ALL CONSTRUCTION GROUP

ADDENDUM NO.: 01
PROJECT NAME: North Park Village (NPV) Administration-Building C (Bid Package 1 – Campus Signage)
PROJECT NO.: 04038
DATE OF ISSUE: 6/8/2023

NOTICE OF CHANGES, MODIFICATIONS, OR CLARIFICATIONS TO CONTRACT DOCUMENTS

CAMPUS SIGNAGE PACKAGE ADDENDUM #1 2023.06.07

3 BUILDING SIGN CALLOUT
SCALE: 1 1/2" = 1'-0"

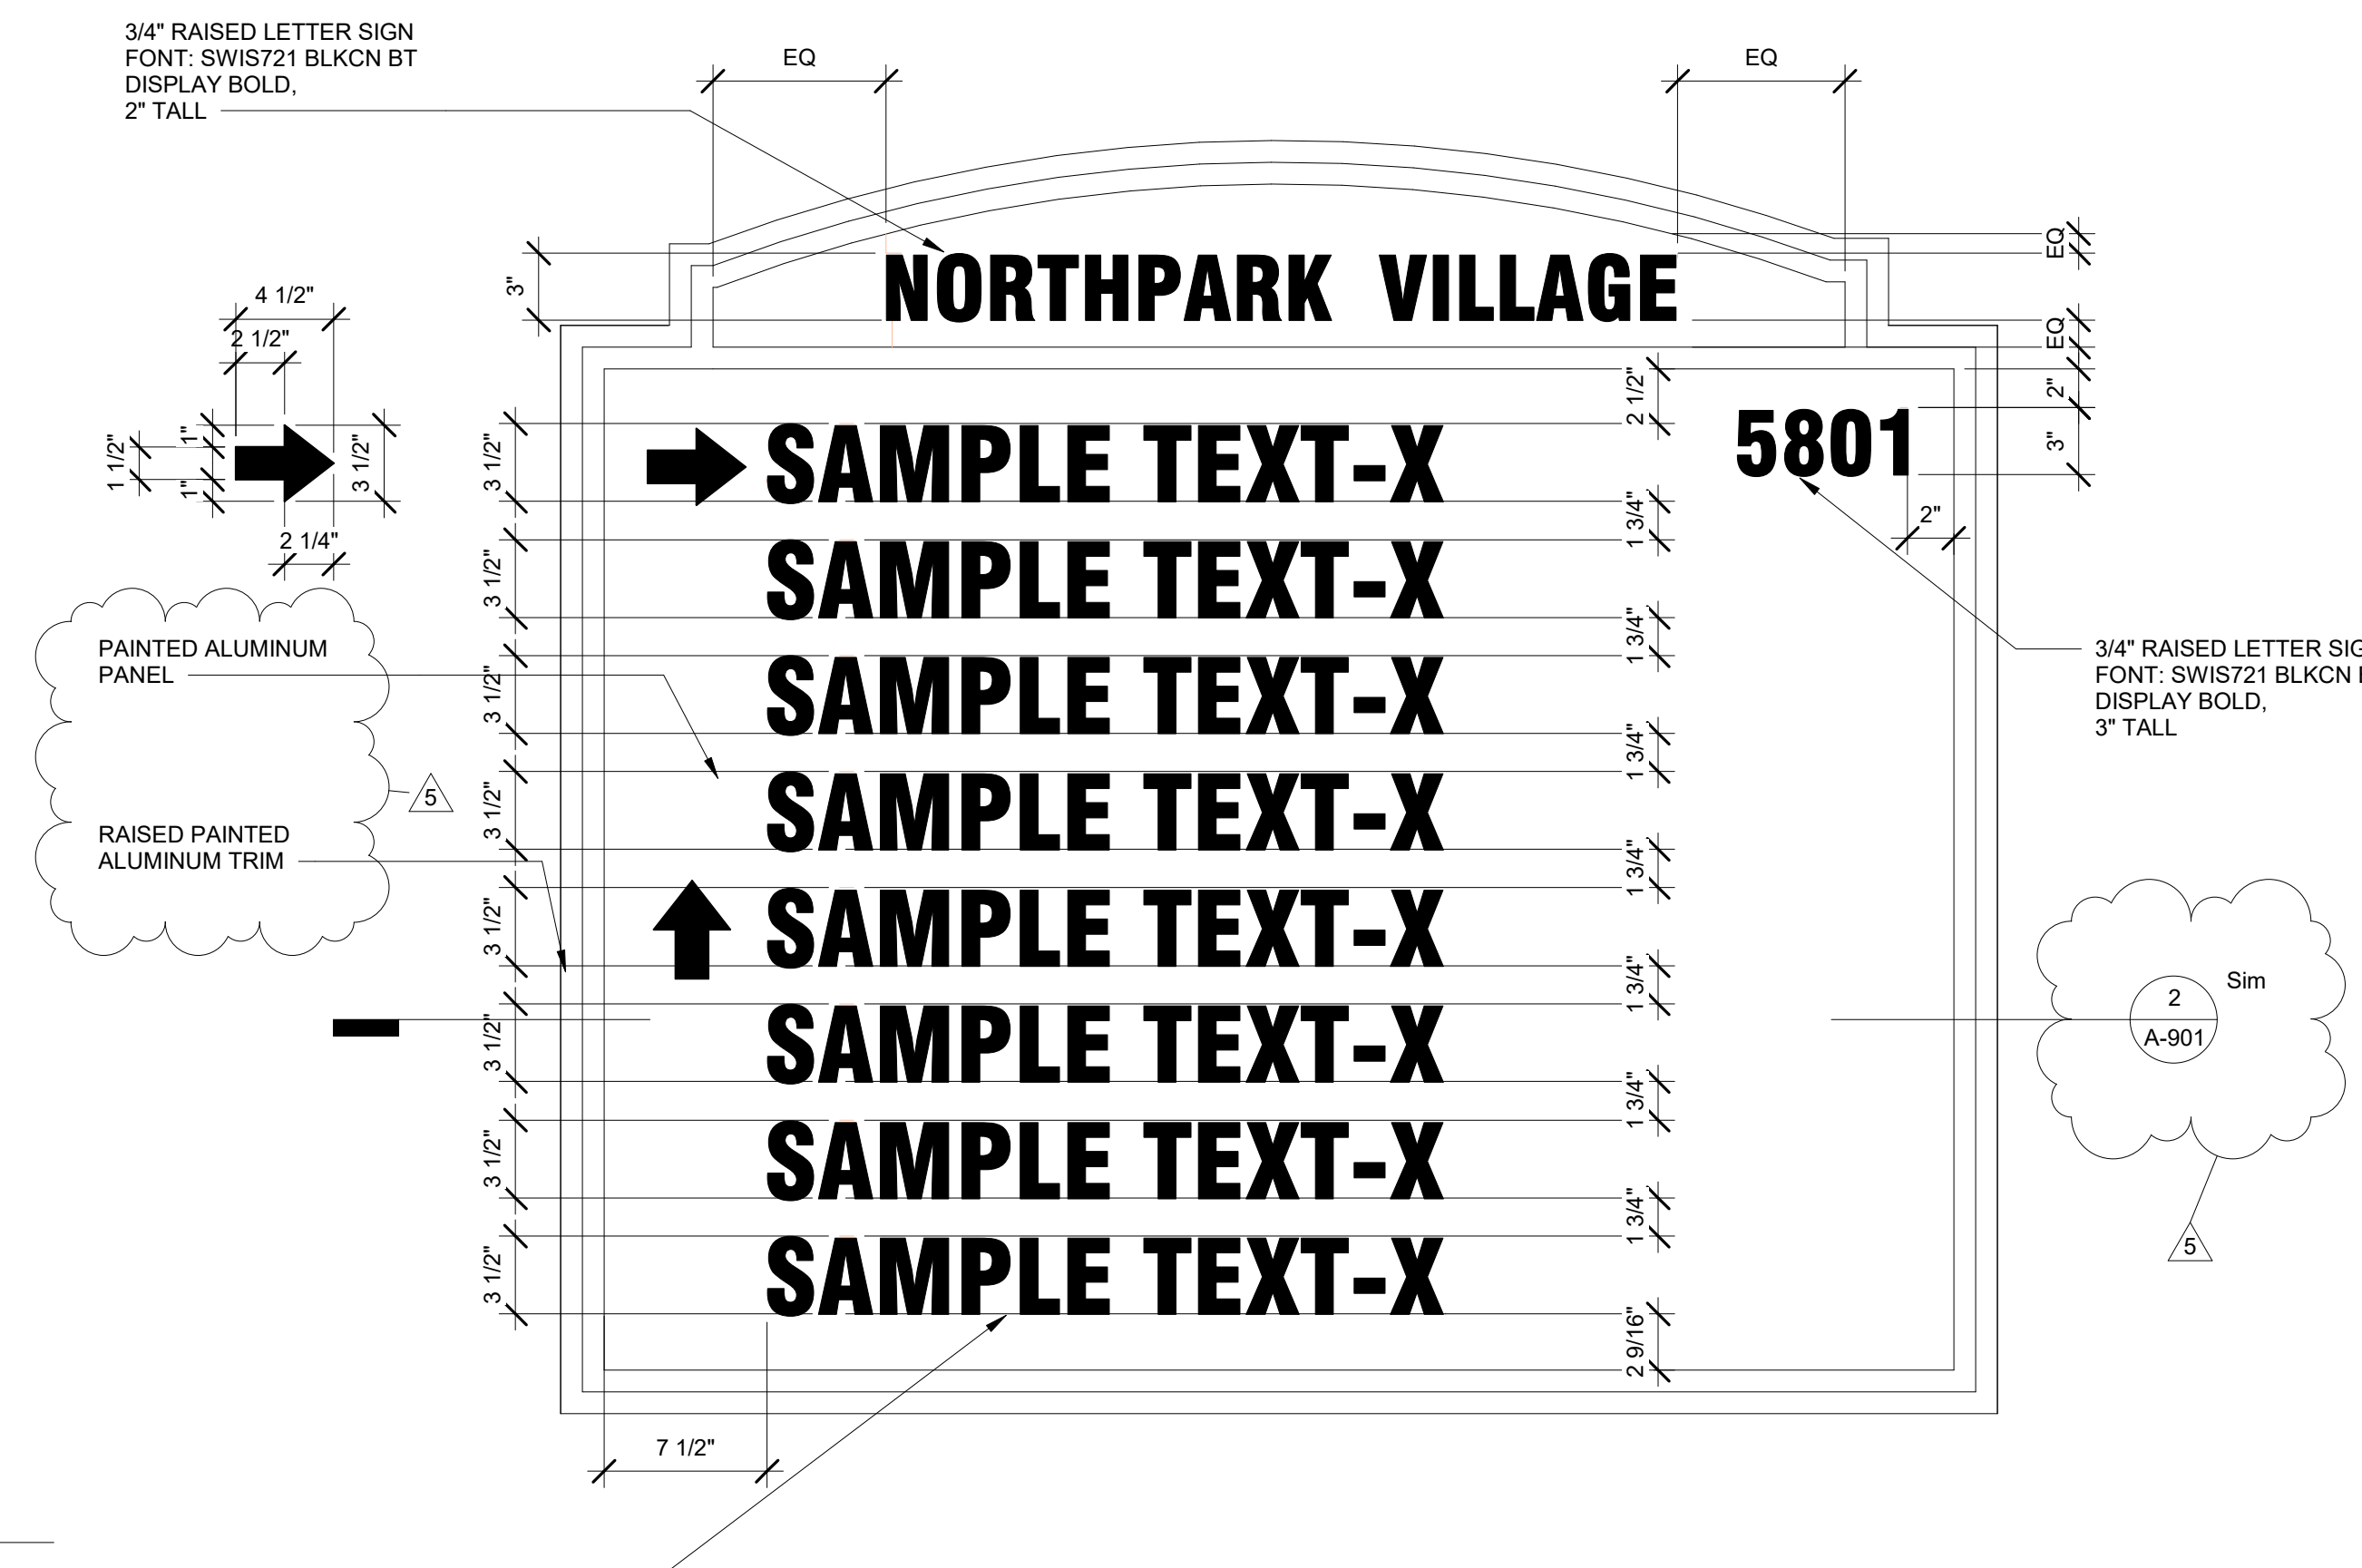
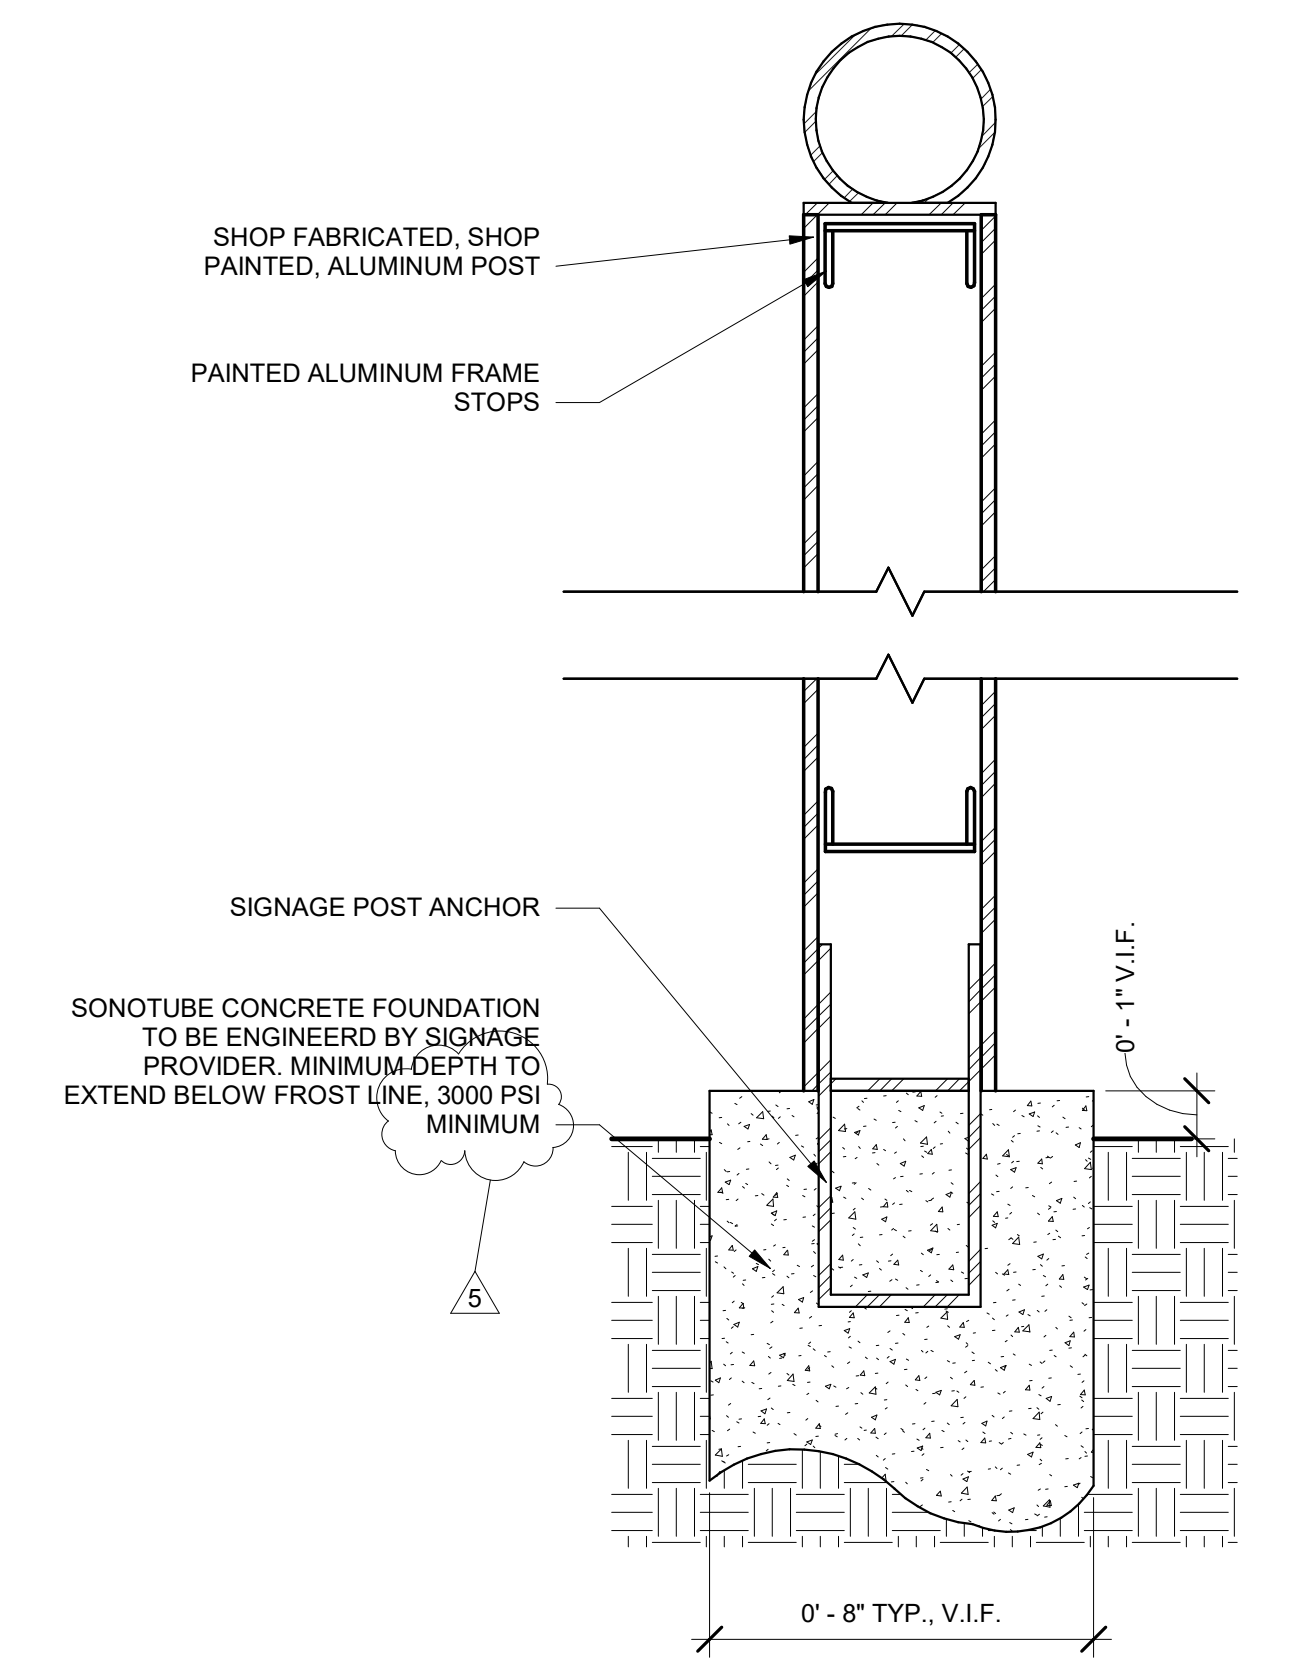
Change 4 **Revised** A-902, added notes regarding Aluminum Back Panel, Concrete Footing PSI, and Trim and addition of reference to cross section detail.

Question 2 We have gone through the drawings and are currently pricing everything. There is no information on the backer panel all the letters / maps are installed on. Do you have any more info or should

we make some assumptions? In addition, the letters are called out at $\frac{3}{4}$ " thick which is expensive, any interest in going to $\frac{1}{4}$ or $\frac{1}{2}$ to save money?

Answer: Back panels are to be painted aluminum. Letters are to be $\frac{3}{4}$ " thick as indicated on the Contract Documents. Please refer to revised Sheets A-901 and A-902.
